THE ROVER COMPANY LIMITED
S E R V I C E D E P A R T M E N T

Rover Service News Letter No. 40

January 29th, 1954

At fig. 3 the incorrect positions of the toggle are shown by dotted lines.

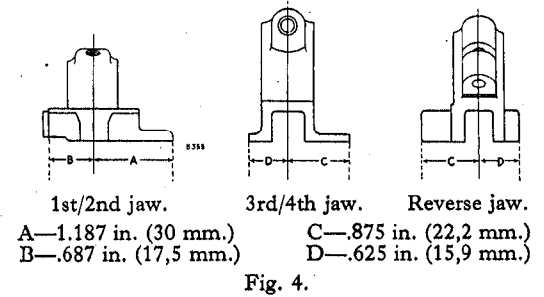
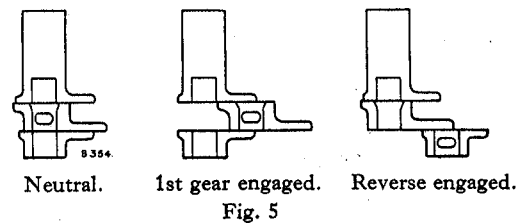
When a gear is selected, e.g. 1st gear, the main selector toggle can disengage from the 1st/2nd selector jaw and pass the "ear" of either the 3rd/4th or reverse jaw. Similarly, with reverse gear engaged the toggle can pass the ear of the 1st/2nd jaw.

Lengthen the jaw ears to the dimensions given at fig. 4 or fit modified jaws (1st/2nd jaw Part No. 230384, 3rd/4th jaw Part No. 230389 and reverse jaw Part No. 230393).

The toggle will then remain in the correct jaw as shown at fig. 5.

**Item 31 PLUNGER FOR
OIL PRESSURE
RELEASE VALVE
1954 "60" and "90"**

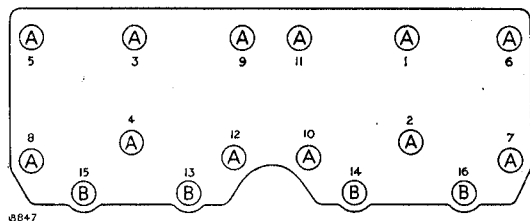
To eliminate tipping on assembly the head diameter of the Plunger for oil pressure release valve has been increased to $\frac{19}{32}$ in. (15.08mm). The new Plunger will be supplied under Part No. 245940 and has been fitted on production from Engines numbered 60: 43300709 onwards and 90: 45301002 onwards.

Only the latest type Plunger will be used for all Service replacements.

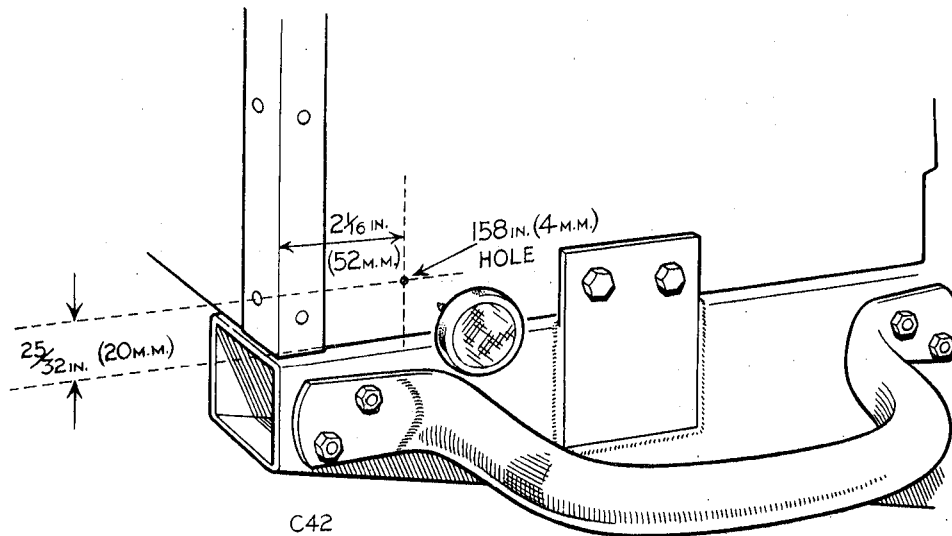
Larger diameter brakes (2 $\frac{1}{4}$ " x 11") have been fitted to the Land-Rover 107 only from Vehicles numbered 47200228 (and two earlier 47200217 and 47200222), 47230697 (and ten earlier 47230655-658, 47230662, 47230679-683), 47260898, 47730049 and 47760145 onwards.

This modification affects all the wheel brakes, master cylinder and their component parts, front and rear axle assemblies and the chassis frame.

Please note that the latest type of Girling Crimson Brake Fluid WL.V. 23 must be used with the 11" brakes.

Fig. 1. Welding breather pipe baffle.

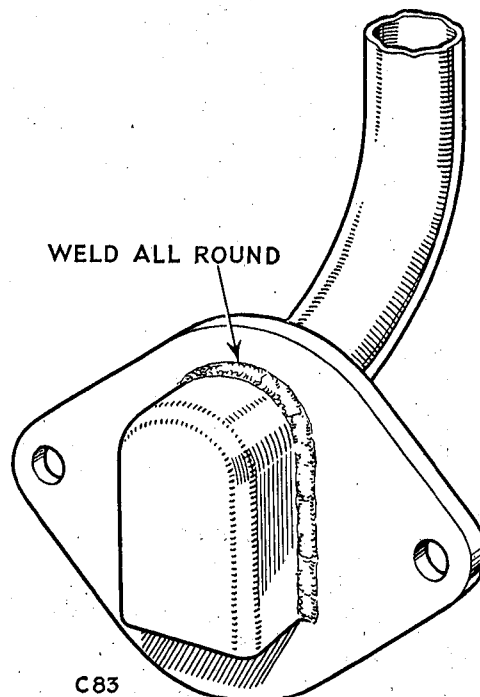
The breather pipe has been modified on Production from Engines number 45303920 onwards by welding all round the baffle.

Where a complaint of high oil consumption after long runs is received, a check should be made in the vicinity of the breather pipe for traces of oil. If oil is found the breather pipe should be removed and the baffle welded all round as shown in the sketch below.

Fig. 2. Front mounting for exhaust pipe.

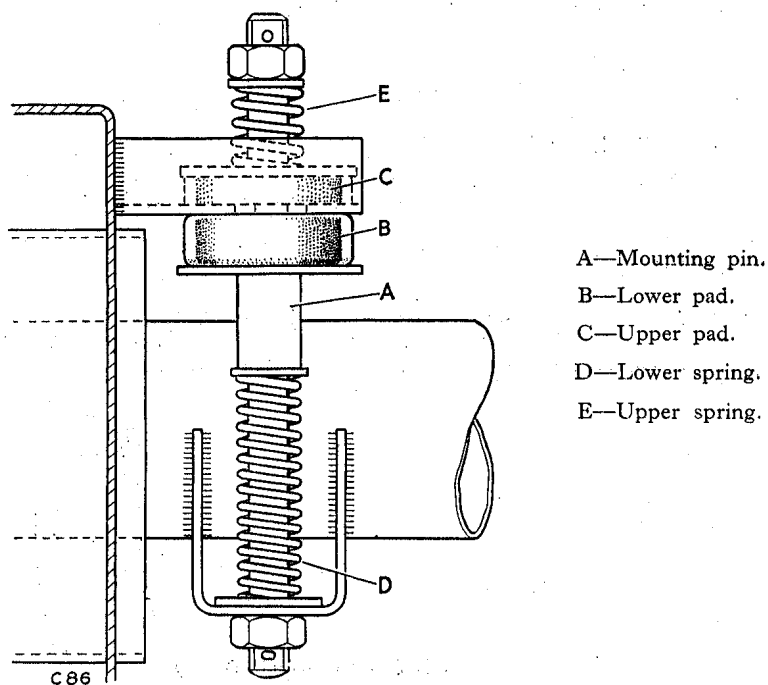
Any earlier 1954 Car can be modified if the parts above are supplied and in addition one plain washer, Part No. 2550, and one split pin, Part No. 2389, are also used. The sketch below shows the method of assembly.

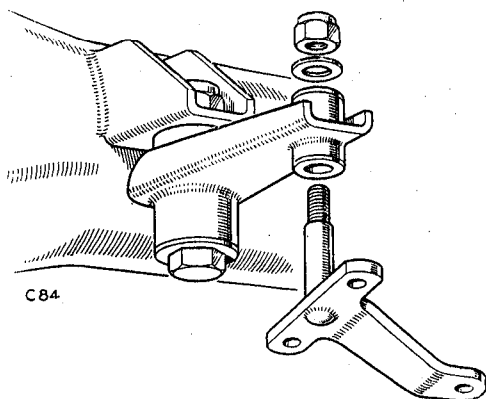
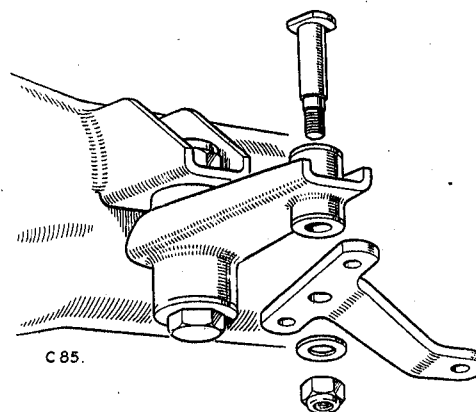
- Item 67** **SUBJECT:** Rear brakes.
MODELS: 1954 "60", "75" and "90".
COMPLAINT: Brakes binding, burning smell from brakes, oil on rear brake shoes.
CAUSE: Seizure of hand brake compensator pivot.
CURE: Dismantle and increase clearance between pin and bushes. On reassembly liberally apply grease to all working surfaces. From cars numbered as below, the pivot pin and lever have been redesigned to give more clearance and will be supplied as two separate items as shown at Fig. 2.
PART Nos. Balance lever: 1 263373.
Pivot pin: 1 263374.
COMM. Nos.: Cars numbered:—

60: 43301650, 43330024, 43360034, 43630001, 43660033 onwards.
75: 44302642, 44330650, 44360504, 44730001, 44760017 onwards.
90: 45302174, 45330583, 45361286, 45830001, 45860017 onwards.
REMARKS: Only the latest type Balance lever and Pivot pin will be supplied for earlier 1954 models; they should be fitted as shown in the sketch below.
